# MISSOURI 2019 AIRPORT LIGHTING PACKAGE

## EAST PACKAGE

### ADDENDUM NO. 1

November 2, 2020

VAULT ENCLOSURE  
PLAN AND DETAILS

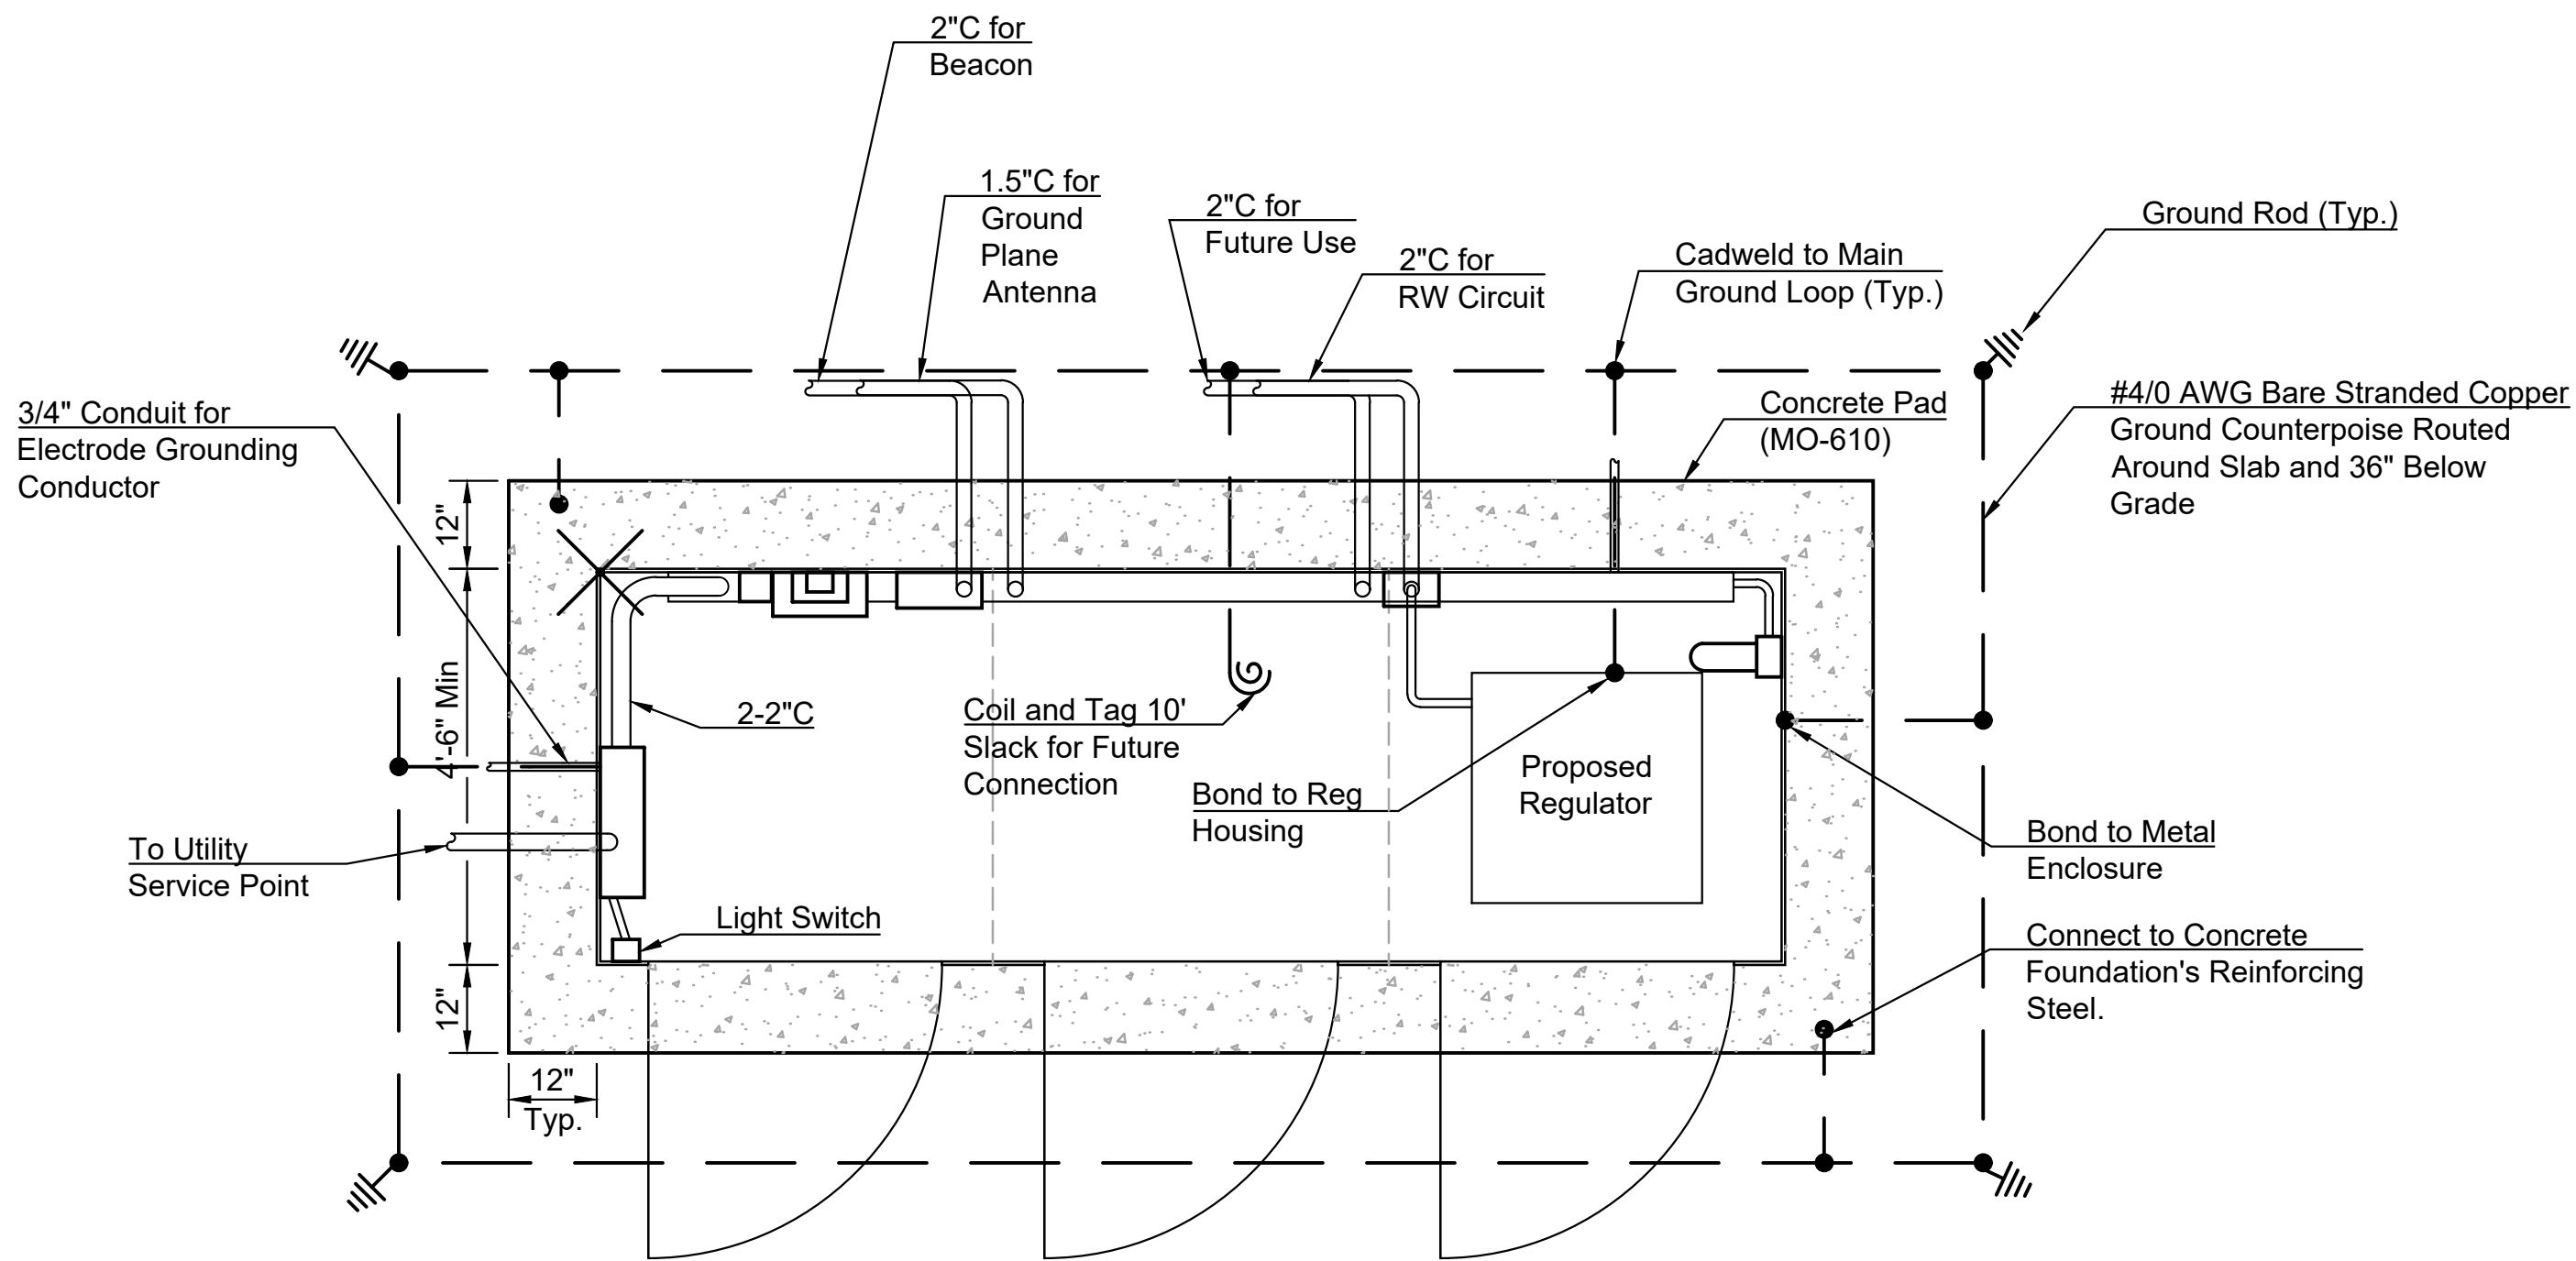
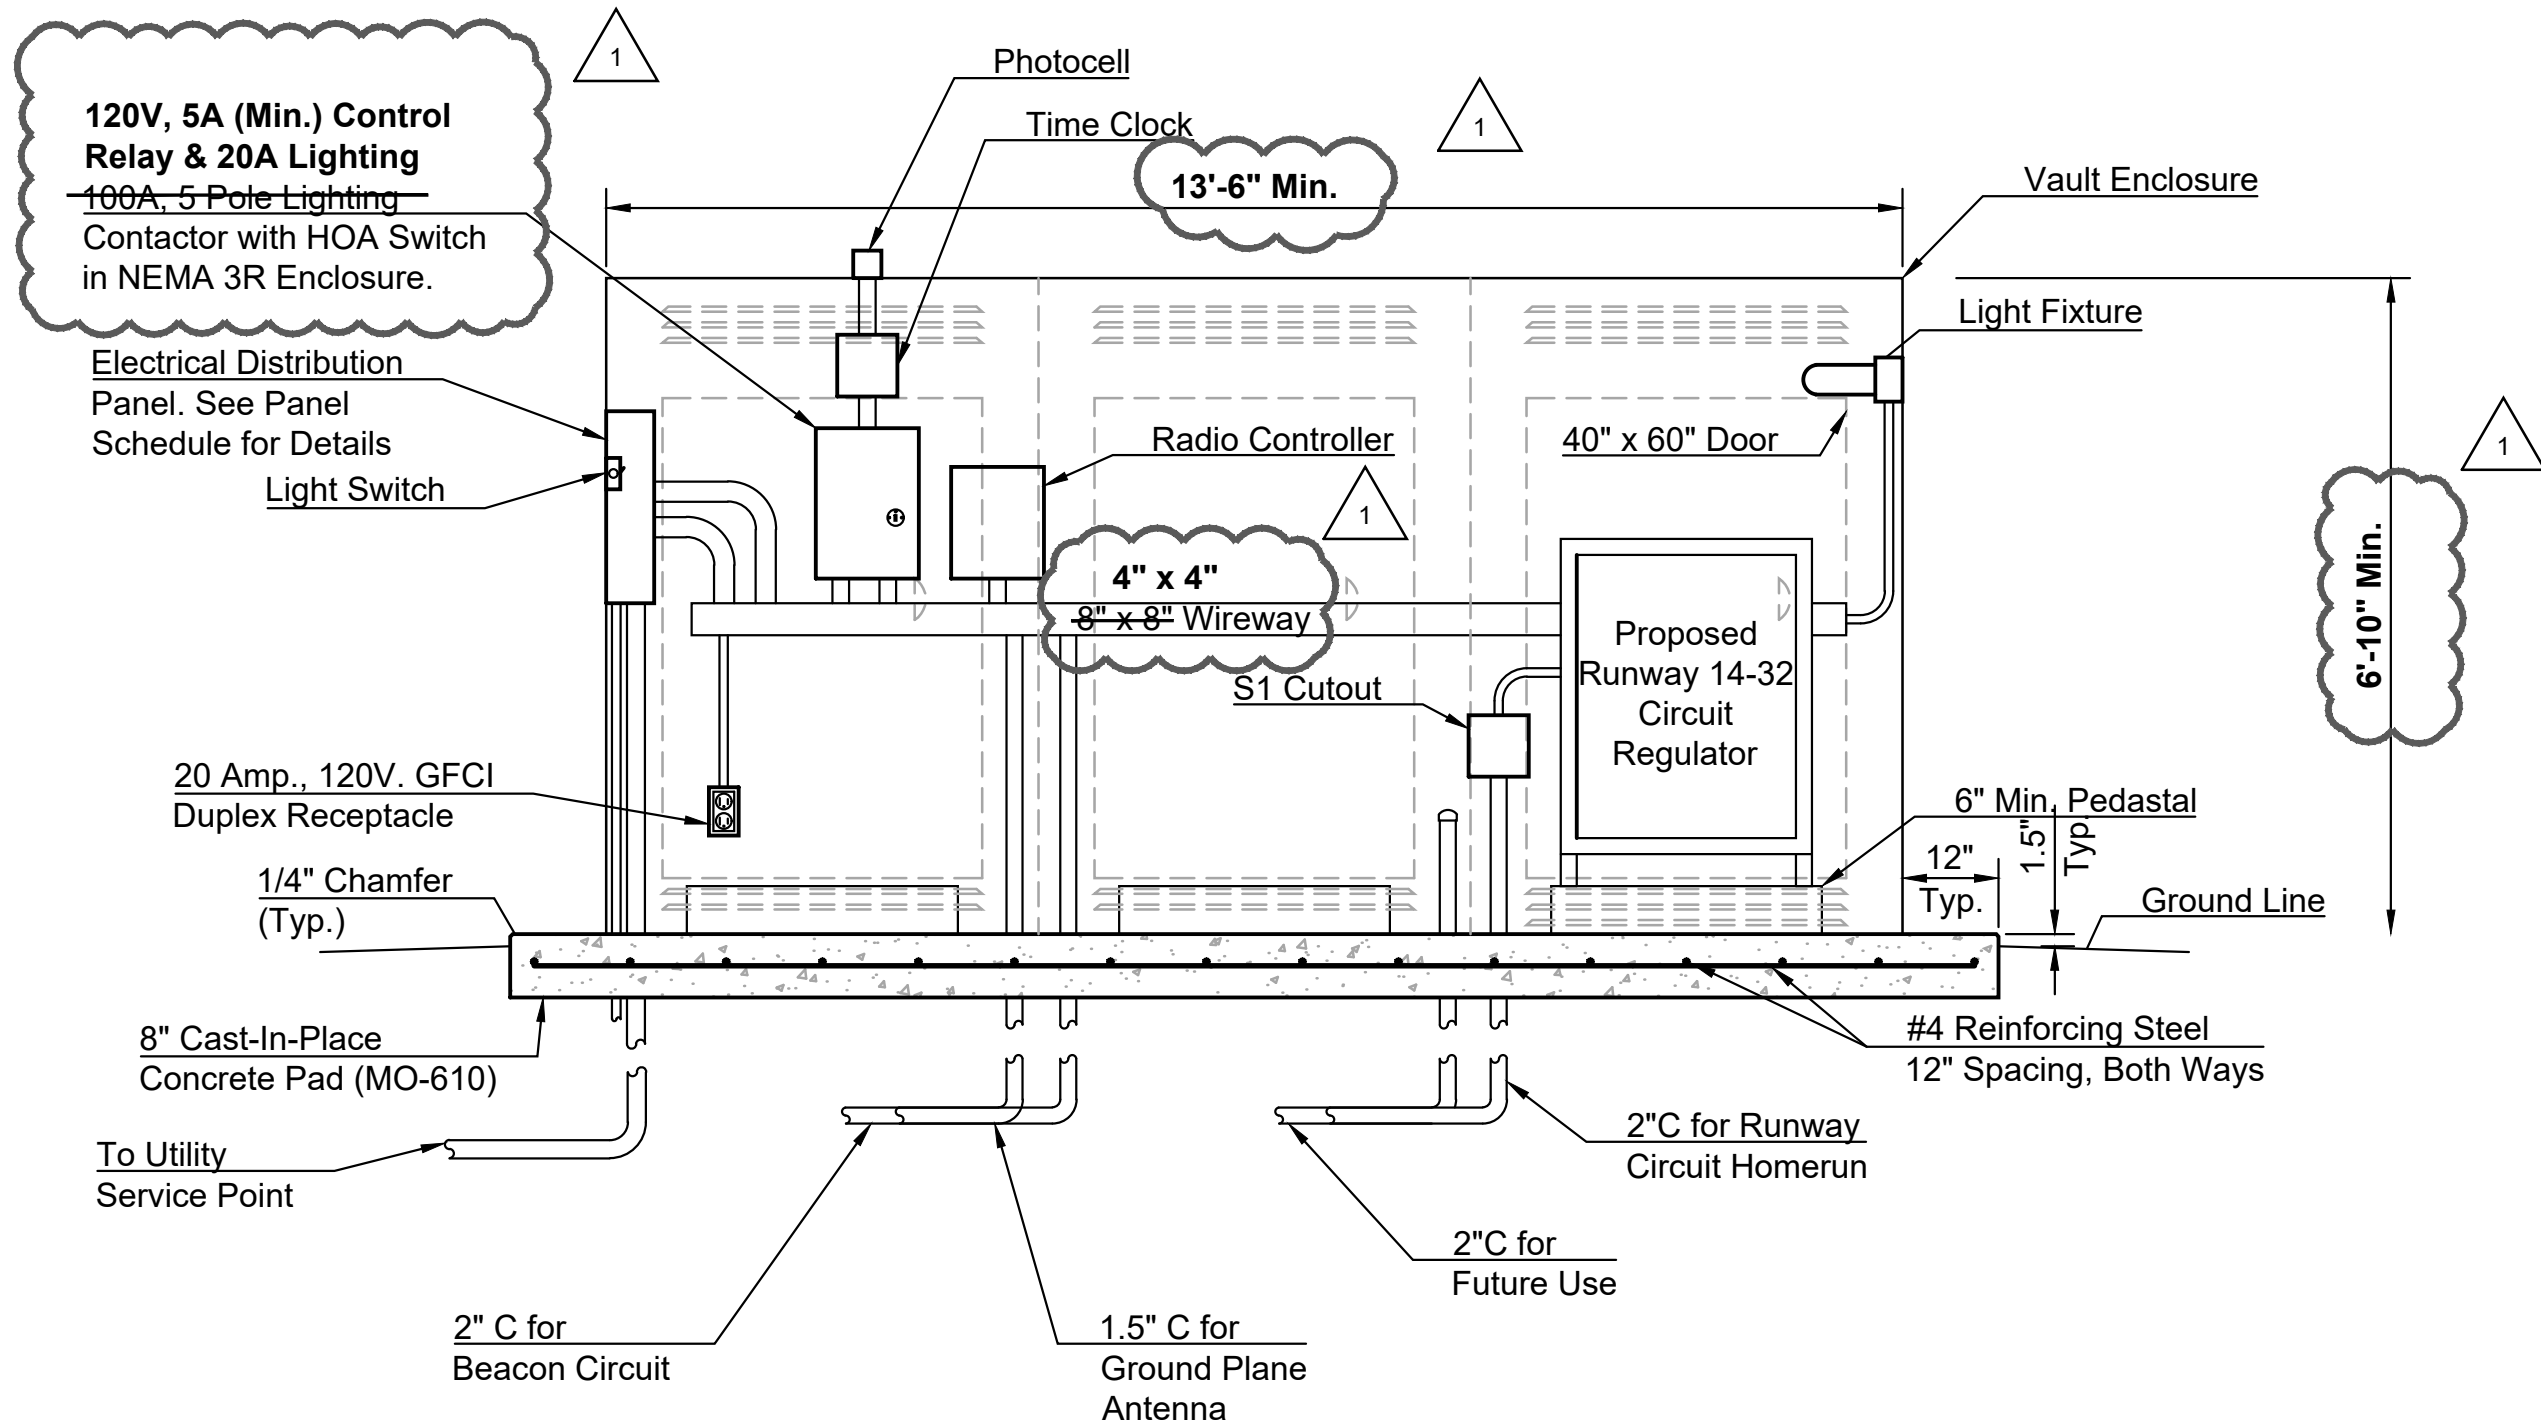
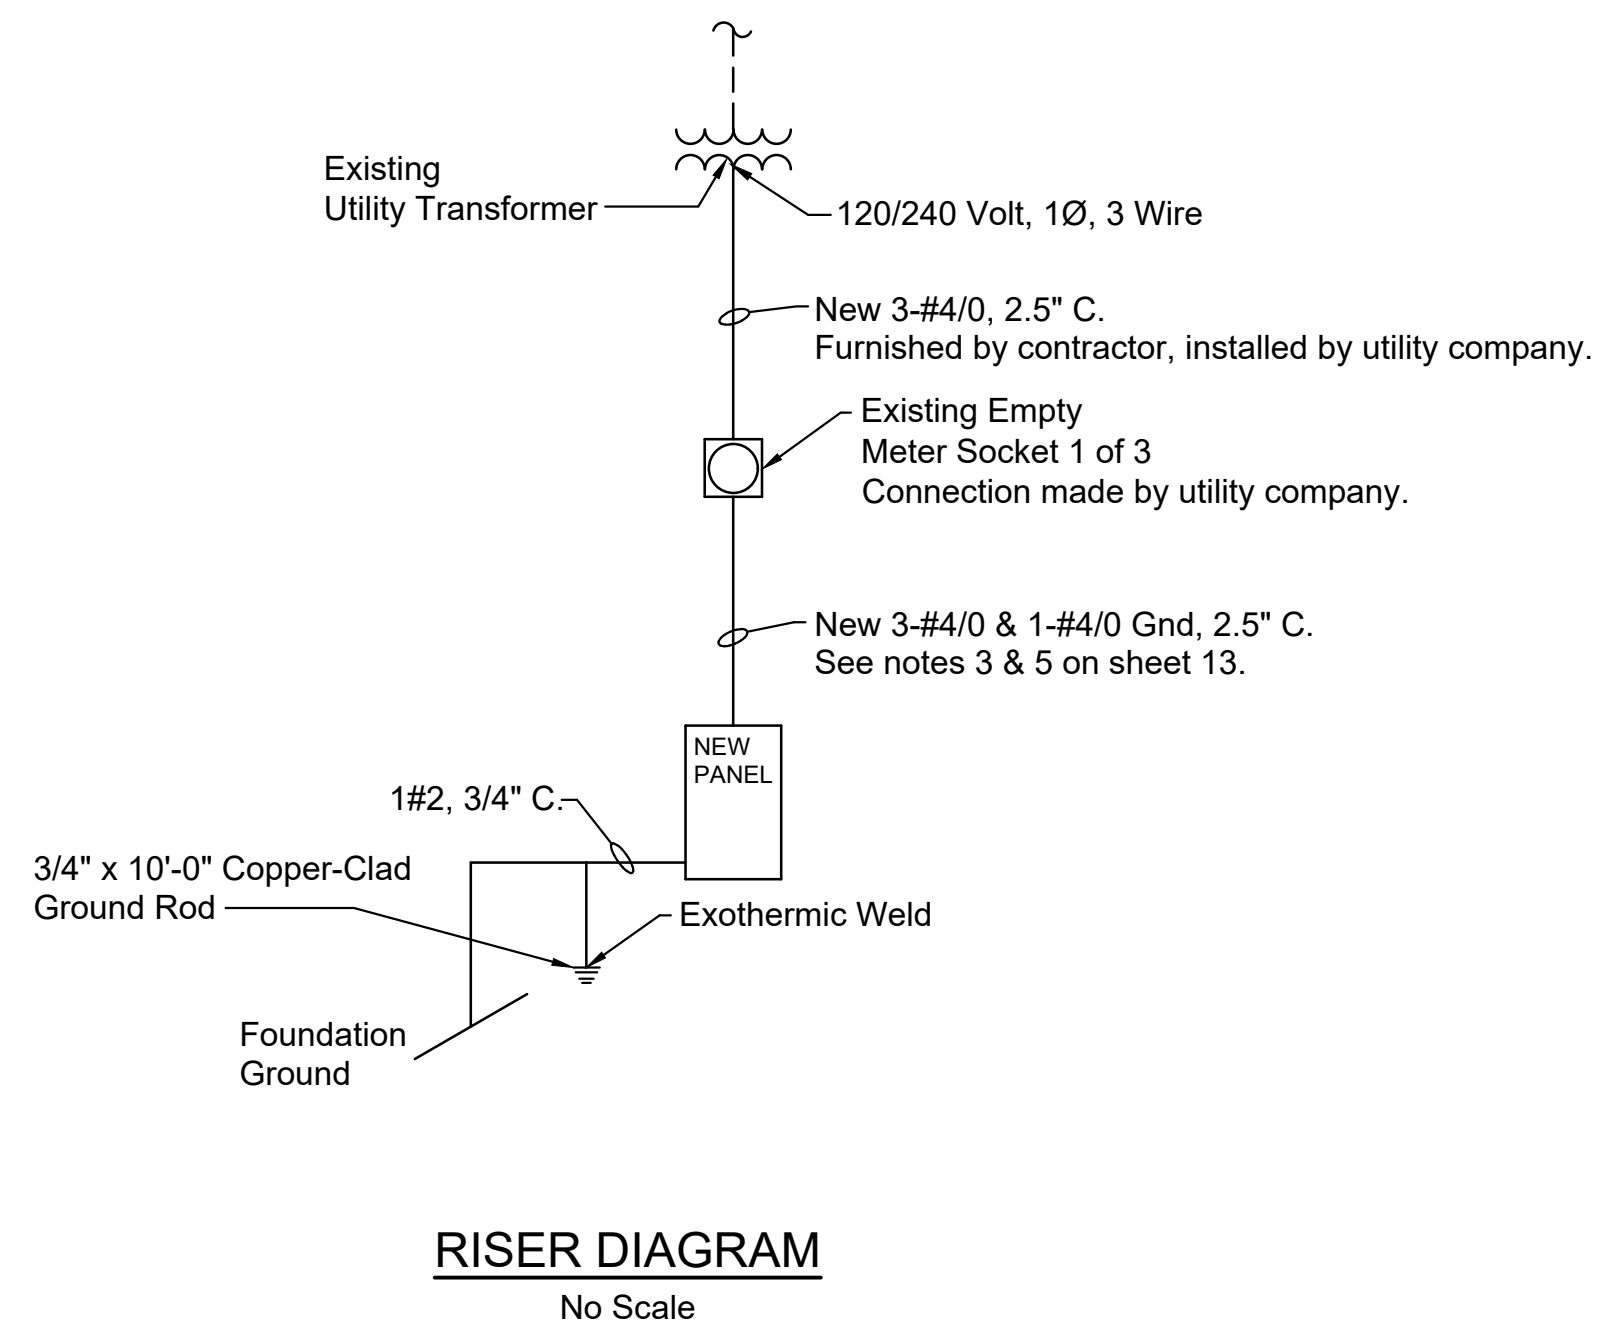
1. **Schedule A: Captain Ben Smith Airfield**, Sheet No. 16 Vault Enclosure Plan and Details. The 8' x 8' wireway is now a 4" x 4" wireway. The 100A lighting contactor for the regulator and wind cone was removed. The regulator will now be controlled via a 120V, 5A (minimum) control relay and the wind cone via a 20A, 2 pole lighting contactor. The PAPI control relay is now a 20A, 2 pole lighting contactor.
